SHOWGROUND PRECINCT EAST

BUILDING A, B & C

SSD 62802207 MOD Proposed Facade Changes- Comparison Schedule

PROPOSED FACADE DEVELOPMENT

BUILDING B- ELEVATION COMPARISON

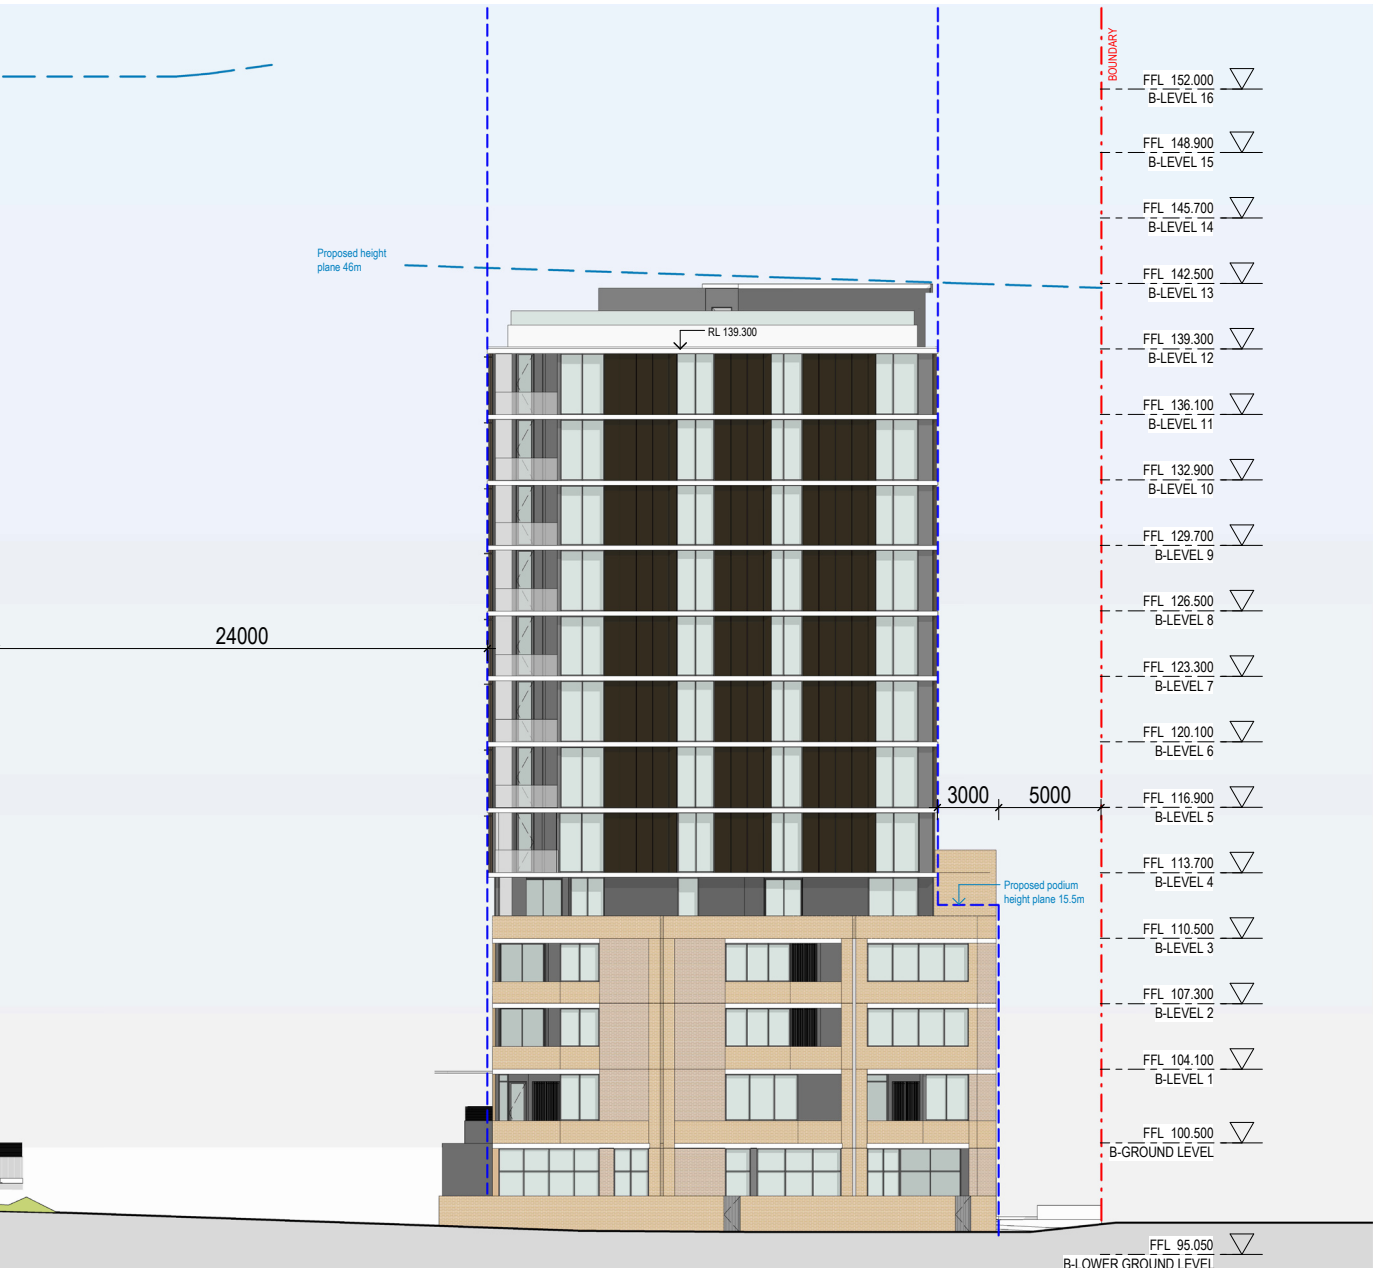
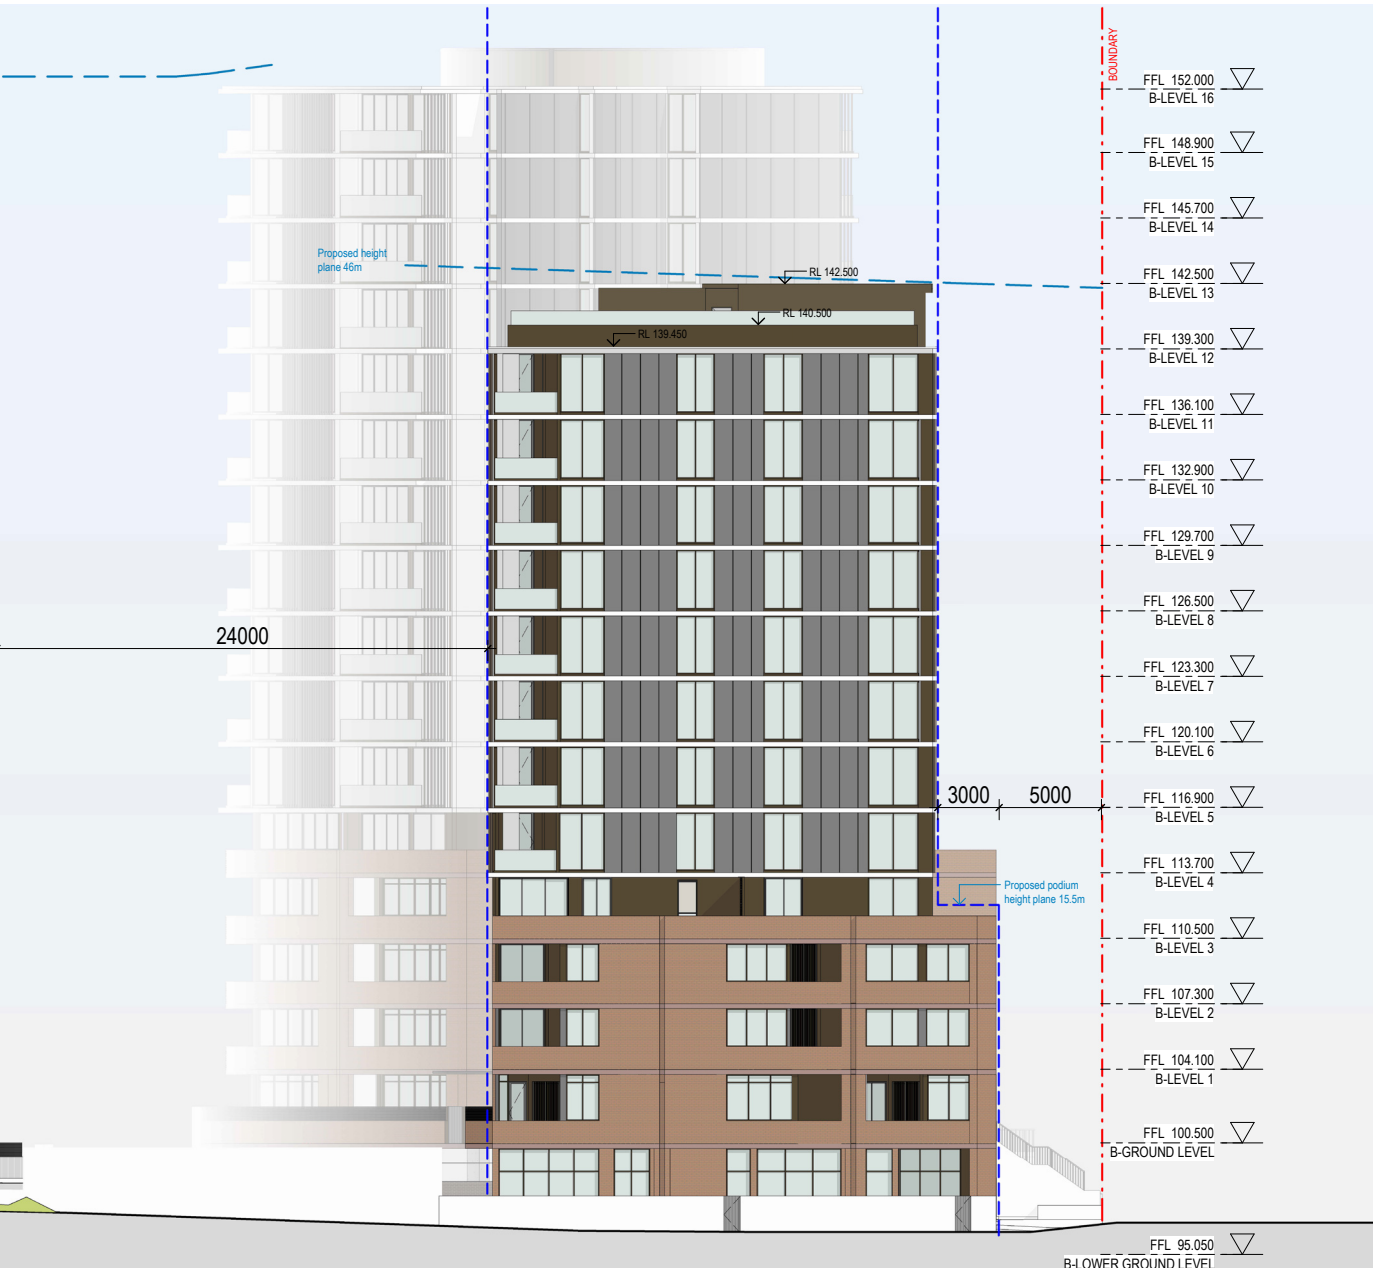
- A. Replaced applied tiles at podium levels with brickwork
- B. Exposed painted slab to podium level
- C. Replaced metal cladding/ brick panels to FC cladding to all tower facade
- D. Rationalised balustrades type to either full glass balustrade or full solid balustrade
- E. Adjustment to screens
- F. Lift and stair core walls changed to rendered and painted finish
- G. Upgrade windows at level 1-3 in Building C to full height glazing
- H. Remove roof frame
- N. Remove splay edges in Building A facade

SSD 62802207 Approved Facade Changes
West Elevation

Proposed Facade Changes:
West Elevation

BUILDING C- ELEVATION COMPARISON

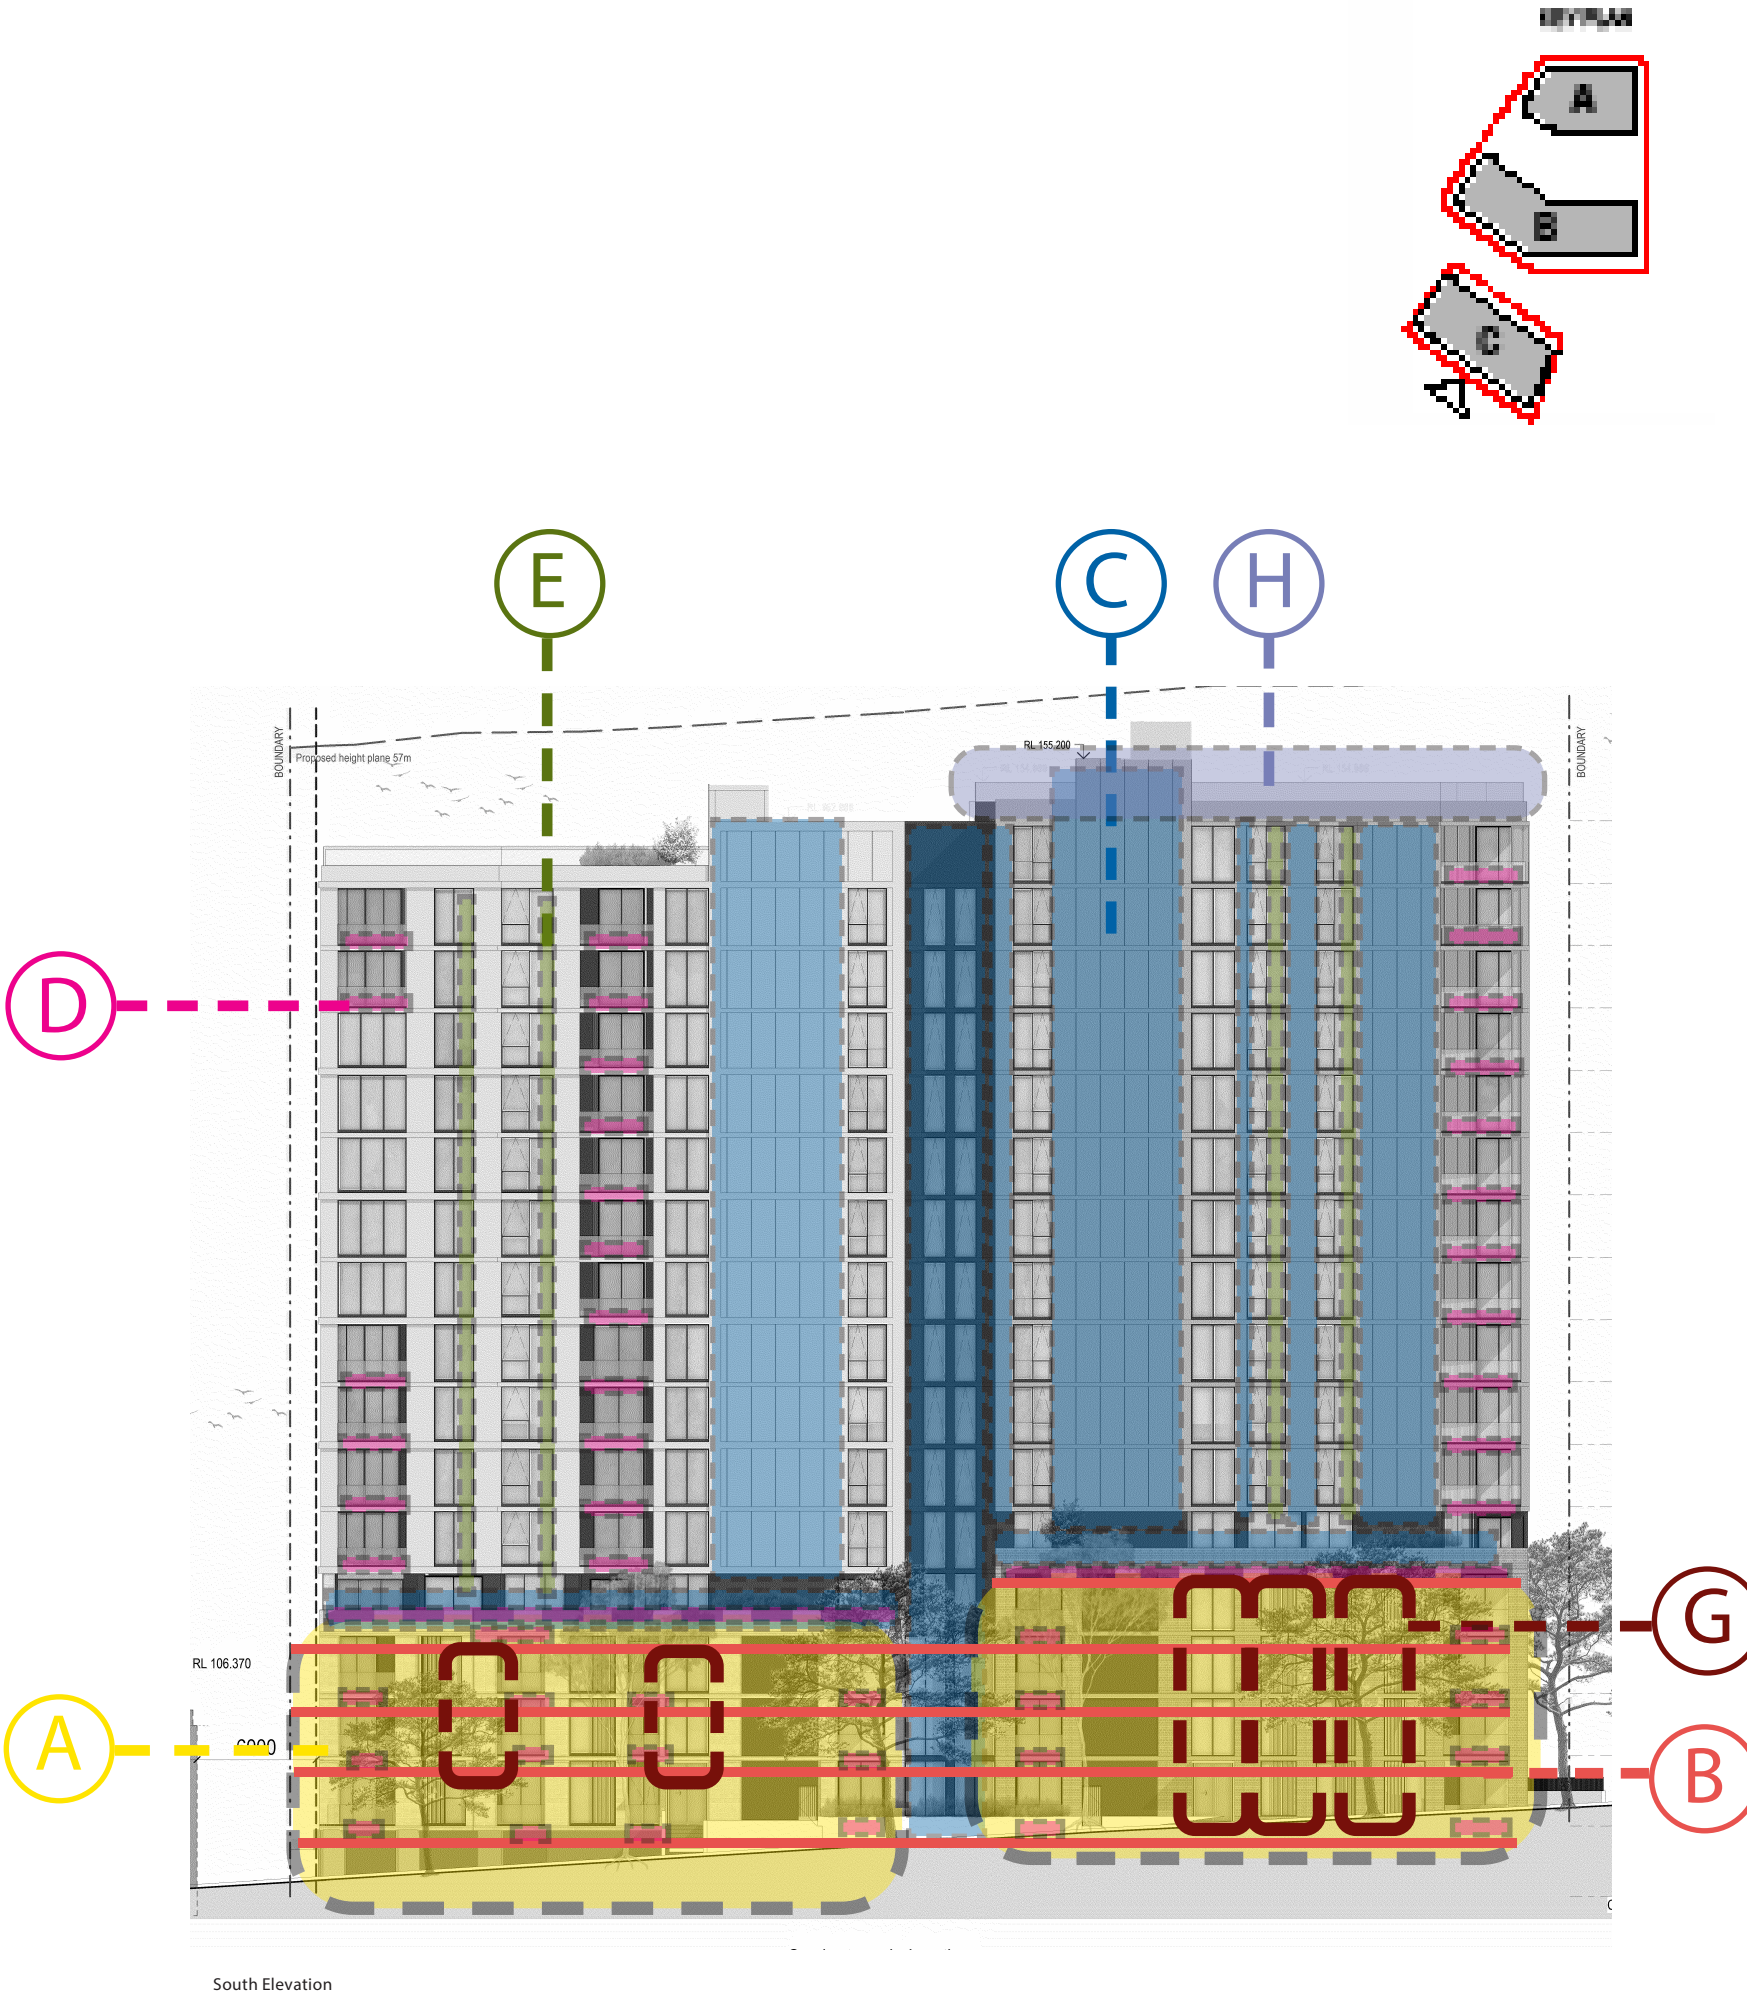
- A. Replaced applied tiles at podium levels with brickwork
- B. Exposed painted slab to podium level
- C. Replaced metal cladding/ brick panels to FC cladding to all tower facade
- D. Rationalised balustrades type to either full glass balustrade or full solid balustrade
- E. Adjustment to screens
- F. Lift and stair core walls changed to rendered and painted finish
- G. Upgrade windows at level 1-3 in Building C to full height glazing
- H. Remove roof frame
- N. Remove splay edges in Building A facade

SSD 62802207 Approved Facade Changes
North Elevation

Proposed Facade Changes:
North Elevation
